**Architectural Review Committee Meeting
September 28, 2022**

4:00 p.m. Shulsen Apartment Project (10115 S. Monroe Street) John Bankhead, David Denison, Howard Cooke (Gardner Group), Soong Kim (Architect), Sam Evans (Wasatch), Richard Gilbert (ArcSitio - Landscape Architect)

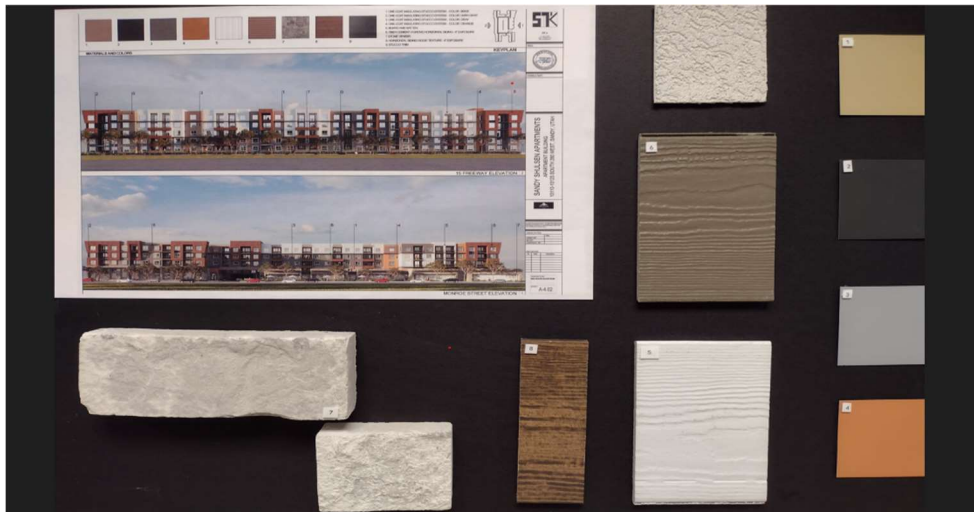
Mike suggested another idea they might want to explore. He thought introducing a clerestory window element with different floor to ceiling heights on the upper level would help create some variation to the long horizontal plane of the building. This could help draw the eye upward and help break up the long horizontal plane.

Soong, in his opinion, thought the intent of those form-based design guidelines was to avoid any long or flat walls that goes vertical or horizontal for a long distance without any articulation. He feels that this this project shows every segment of the facade and is well articulated.

Lyle thinks that it could be a bit more hierarchy with more pronunciation of the pieces going across the front, especially at the entry. Also, he thought that the top unit row of windows looked homogeneous and wondered if they could have a higher ceiling and be more accentuated allowing the glass to extend higher.

Soong said he could look into that and agreed that he could explore accentuating the corners of the building by raising the corners of the building. Those units that are then on the corners would get a taller feeling with clerestory windows.
